COUNCIL ASSESSMENT REPORT

HUNTER AND CENTRAL COAST REGIONAL PLANNING PANEL

PANEL REFERENCE & DA NUMBER	PPSHCC-267– [DA/2396/2023]
PROPOSAL	Alterations and additions to existing hotel, new bottle shop, 60 room motel, new car parking area and part demolition of existing structures.
ADDRESS	Lot 7 DP658304, Lot 15 DP1061216, Lots 2 and 3 DP 1016073, Lot 7A DP365458, Lot 4 DP1016073 [29-31, 41-45 Victoria Street, 16 and 20 Brougham Street, 27 and 27A Adelaide Street, East Gosford.
APPLICANT	Rachel Hulks
OWNER	Bonython Elanora Pty Ltd
DA LODGEMENT DATE	19 December 2023
APPLICATION TYPE	Local
REGIONALLY SIGNIFICANT CRITERIA	Clause 2 Schedule 6 of <i>State Environmental Planning Policy (Planning Systems) 2021</i> : General Development over \$30 million.
CIV	\$31,650,000 (excluding GST)
CLAUSE 4.6 REQUESTS	Not Applicable
KEY SEPP/LEP	<ul style="list-style-type: none"> • Environmental Planning and Assessment Act 1979 s4.15. • State Environmental Planning Policy (Transport and Infrastructure) 2021 • State Environmental planning Policy (Resilience and Hazards) 2021 • Central Coast Local Environmental Plan 2022 • Central Coast Development Control Plan 2022.

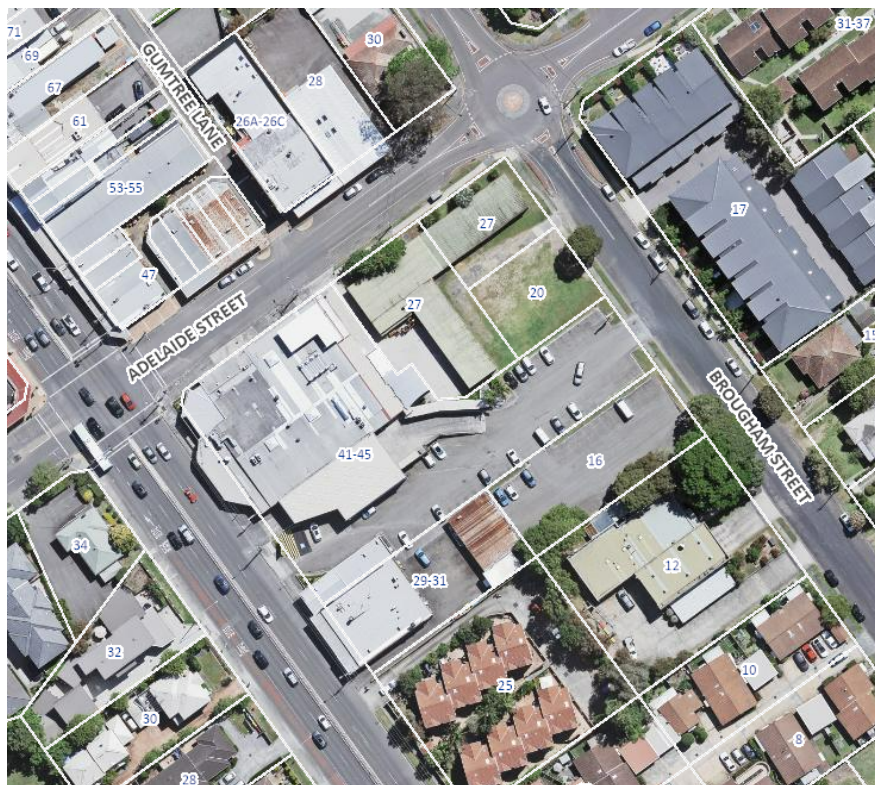
It is noted that Council's Waste Officer has raised the following matters:

- *That the Development Engineer check the swept travel plans to make sure that a HRV can access the site and exit in the path that has been proposed,*
- *there is some potential overhead clearance issues regarding the HRV driving into the collection point and leaving the collection point, just need to confirm that there is enough clearance between the building and the proposed garden bed and the truck won't be obstructed.*

In relation to the vehicular manoeuvrability, swept turning paths of the 12.5m HRV provided appear to be satisfactory. In relation to overhead clearances, the applicant has now advised "As shown on the architectural plans, no part of the waste truck travel path is roofed or enclosed, which would require a 4m overhead clearance to be demonstrated". This is noted.
